# UNITED STATES PATENT AND TRADEMARK OFFICE

APPLICATION NO.	FILING DATE	FIRST NAMED INVENTOR	ATTORNEY DOCKET NO.	CONFIRMATION NO.
10/518,068	06/16/2005	Christophe Loustaudaudine	V3.12-1	3636

## Office Action Summary

## **DETAILED ACTION**

Figure 1: Figure 1 from US Patent 1,608,822

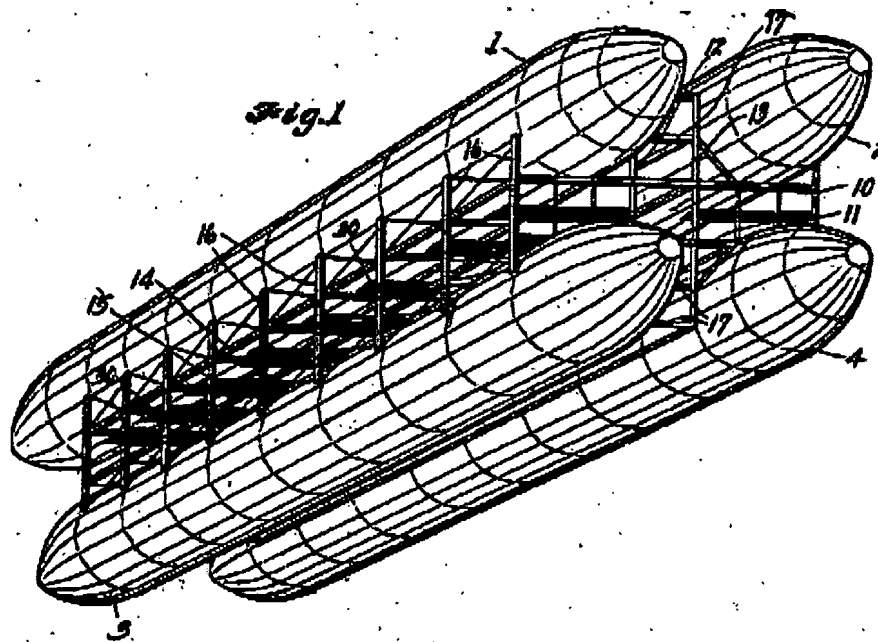
11. Regarding claim 1, with reference to Figure 1, Silver discloses a lighter than air aircraft comprised of two balloons (1) and (2) that are connected by a means forming a chassis (page 1, lines 9-11).

12. Regarding claim 3, with reference to Figure 1, Silver discloses an aircraft with the limitations of claim 1 as discussed above, and a connecting means formed by (10), (11), (12), (13), (14), (15), (16), and (17) connecting the two balloons through a mechanical connection (page 2, lines 12-14) that is articulated about an axis parallel to the longitudinal axis of the aircraft (page 1, line 96- 97).

32. Regarding claim 30, with reference to Figures 1 and 5, Silver discloses an aircraft with the limitations of claim as discussed above, further characterized in that the balloons (1), (2), (3), and (4) are approximately cylindrical in shape.

Figure 2: Figure 2 from US Patent 1,608,822

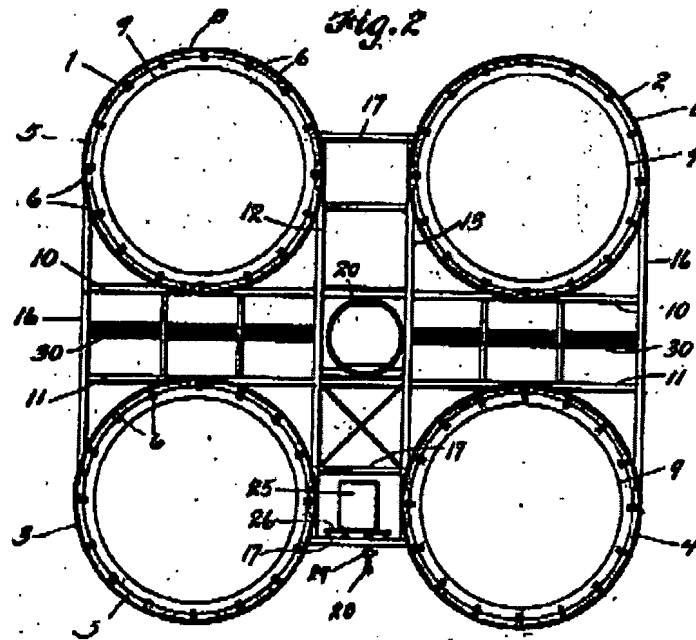
13. Regarding claim 5, with reference to Figure 2 Silver discloses an aircraft with the limitations of claim 1 as discussed above, and a carrying means (20) designed to support equipment and or at least one person (page 2, lines 36-37).

14. Regarding claim 6, with reference to Figure 2, Silver discloses an aircraft with the limitations of claim 5 as discussed above, further characterized by carrying means (20) lying within the volume between the balloons (1), (2), (3) and (4).

15. Regarding claim 7, with reference to Figure 2, Silver discloses an aircraft with the limitations of claim 1 as discussed above, further characterized by a connecting means formed by (10), (11), (12), (13), (14), (15), (16), and (17) forming a symmetric assembly.

16. Regarding claim 8, with reference to Figure 2, Silver discloses an aircraft with the limitations of claim 1 as discussed above, further characterized with a balloon (1) and (2), on each side of the connecting means.

17. Regarding claim 9, with reference to Figure 2, Silver discloses an aircraft with the limitations of claim 1 as discussed above, further characterized with a balloon (1) and (3), on each side of the connecting means.

18. Regarding claim 11, with reference to Figure 2, Silver discloses an aircraft with the limitations of claim 9 as discussed above, further characterized by balloons (1) and (3) placed one above the other.

Figure 3: Figure 4 from US Patent 1,608,822

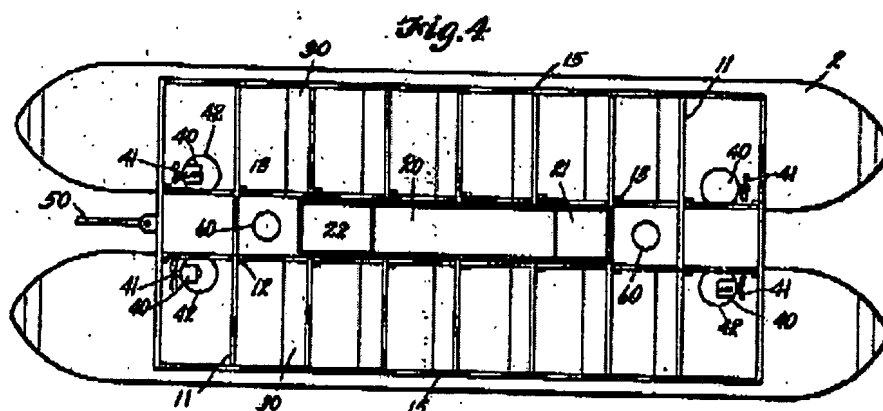
21. Regarding claim 14, with reference to Figure 4, Silver discloses an aircraft with the limitations of claim 12 as discussed above, further characterized by a pitch control means (60). Opposite thrusts of the pitch control means (60) can vary the pitch of the aircraft.

22. Regarding claim 15, with reference to Figure 4, Silver discloses an aircraft with the limitations of claim 14 as discussed above, further characterized in that the pitch control means include at least two engines (60) installed approximately on the longitudinal axis of the aircraft, on forward and one after the center of gravity of the aircraft.

31. Regarding claim 28, with reference to Figure 4, Silver discloses an aircraft with the limitations of claim 22 as discussed above, further characterized in that the directional means comprise at least two orientation engines (40) mounted with respect to each other so as to produce thrusts in the opposite direction. "Each of these engines... is mounted on a horizontally rotatable turret..." (page 2, lines 92-95). These engines are able to rotate to produce thrusts in opposite directions.

Figure 4: Figure 3 from US Patent 1,608,822

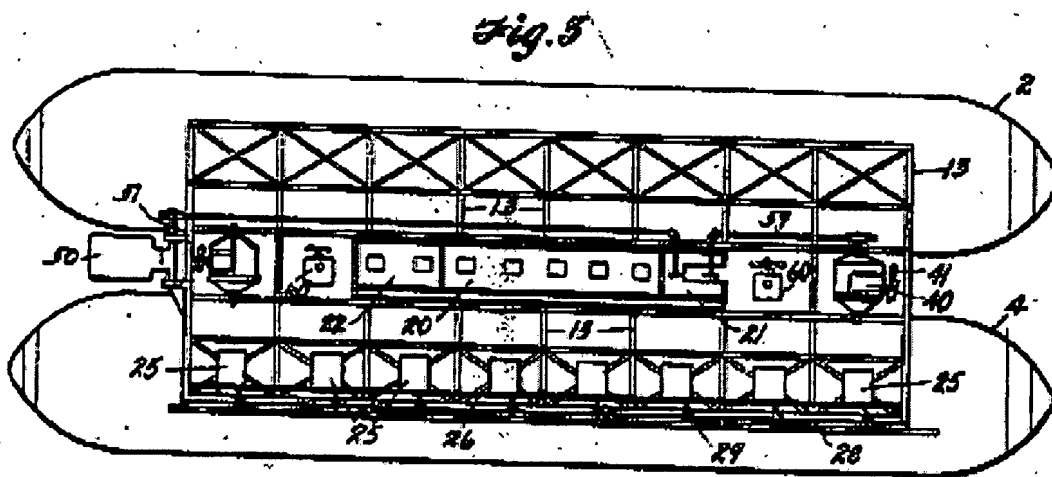
30. Regarding claim 27, with reference to Figures 3 and 5, Silver discloses an aircraft with the limitations of claim 22 as discussed above, further characterized in that the

directional means comprise at least one orientation engine (40) installed so as to produce at least a thrust transverse to the longitudinal axis of the aircraft. "Each of these engines... is mounted on a horizontally rotatable turret..." (page 2, lines 92-95). These engines are able to rotate to produce thrusts transverse to the longitudinal axis of the aircraft.

**Figure 3 from US Patent 5,026,003**

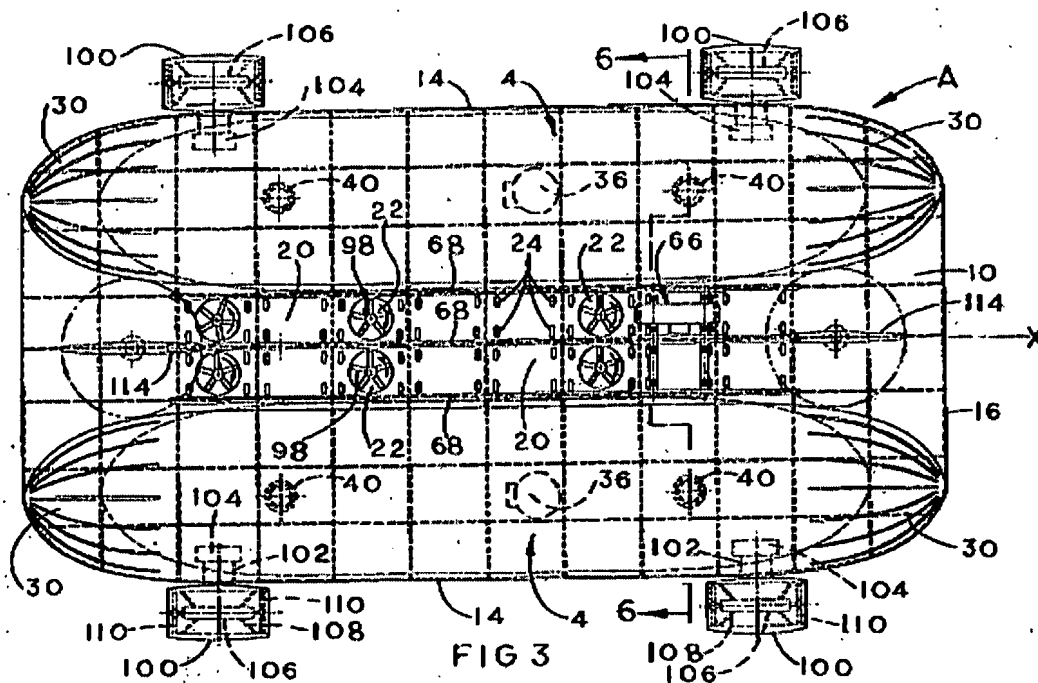
38. Regarding claim 17, with reference to Figure 3 Smith discloses an aircraft with the limitations of claim 16 discussed above, further characterized in that the roll control means comprise at least two engines (106) installed on each side of the longitudinal axis of the aircraft in an approximately horizontal plane.

45. Claim 18 is rejected under 35 U.S.C. 103(a) as being unpatentable over Smith US Patent 5,026,003. Smith, with reference to Figure 3, teaches the limitations of claims 1, 9, 11 and 16 as discussed above. Smith does not teach roll control means comprising roll control engines mounted on an axis perpendicular to the longitudinal axis of the said aircraft and passing through or close to the center of gravity of the aircraft. The roll control means (106) of this aircraft are located away from the center of gravity, as shown in Figure 3. Moving the roll control means closer to the center of the aircraft would centrally locate the mass of the aircraft. It is known by those of ordinary skill in the art that the position of the center of mass of an aircraft affects its stability. Therefore, to achieve more stability it would have been obvious to those of ordinary skill in the art at the time of the invention to relocate the mass, and by doing so relocate the roll control means, to a position on an axis perpendicular to the longitudinal axis of the aircraft passing through or close to the center of gravity of the aircraft.

**Figure 4 from US Patent 5,026,003**

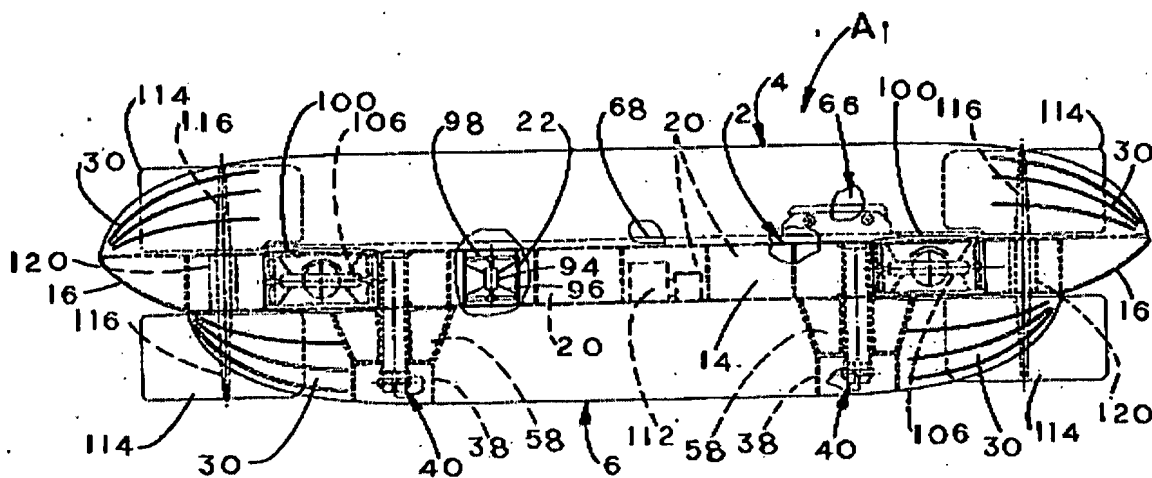
39. Regarding claim 19, with reference to Figure 4 Smith discloses an aircraft with the limitations of claims 1, further comprising stability control means (94)(106) which can act on the altitude of the aircraft.

Figure 5 from US Patent 5,026,003

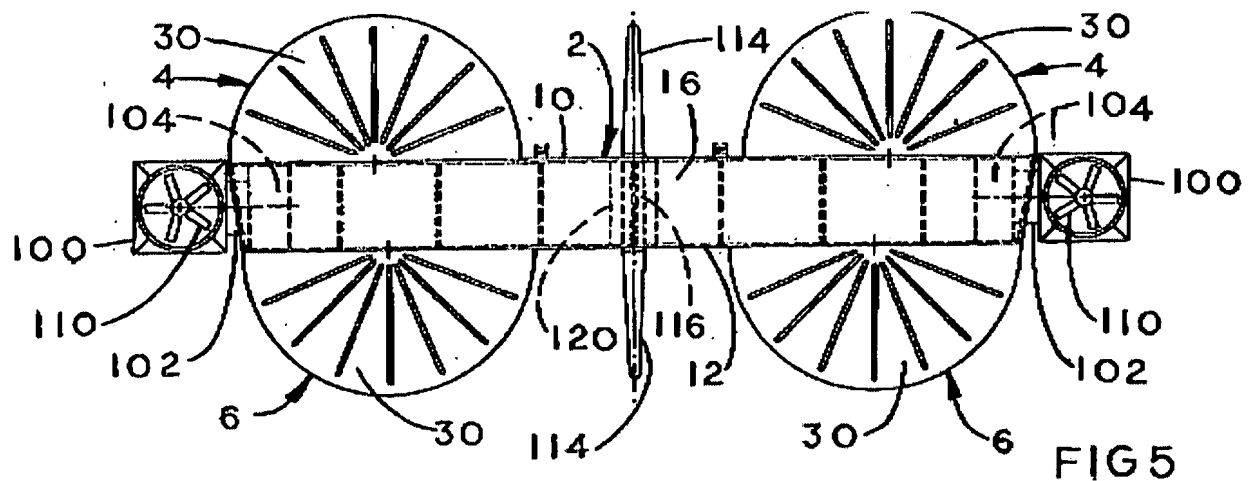
34. Regarding claim 1, with reference to Figure 5 Smith discloses an aircraft characterized in that it comprises at least two balloons (4) connected together by connecting means forming a chassis.

35. Regarding claim 9, with reference to Figure 5 Smith discloses an aircraft with the limitations of claim 1 as discussed above, further characterized in that it comprises two balloons (4) and (6) on each side of the connecting means.

36. Regarding claim 11, with reference to Figure 5 Smith discloses and aircraft with the limitations of claim 9 as discussed above, further characterized in that the two balloons are placed one above the other.

37. Regarding claim 16, with reference to Figure 5 Smith discloses an aircraft with the limitations of claim 11 as discussed above, further characterized in that it comprises roll control means (column 7, lines 4-8). "The motors 106... normally operate in a horizontal orientation, they may be rotated to a vertical orientation where all of the thrust

derived from the motors 106 is exerted vertically,...” Once in the vertical orientation, varying the differential thrust between the two engines controls the roll of the aircraft.

Figure 6: Figure 10 from US Patent 6,581,873

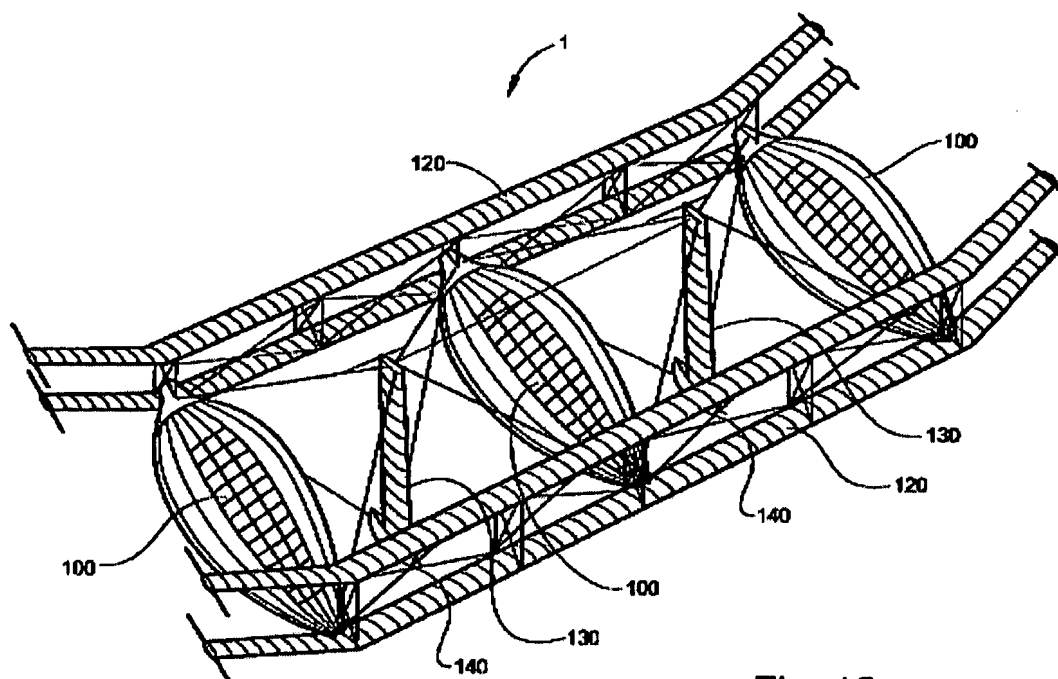
41. Regarding claim 1, with reference to Figure 10, McDermott discloses an aircraft that comprises at least two balloons (100) connected together by a connecting means forming a chassis (120), (130), and (140)
42. Regarding claim 29, McDermott discloses an aircraft with the limitations of claim 1 as discussed above, further characterized in that it comprises a wireless remote control means (column 3, lines 16-17). "...maneuverable by remote control through earth based transmissions."
43. Regarding claim 31, with reference to Figure 10, McDermott teaches the limitations of claim 1 as discussed above, further comprising onboard geographic
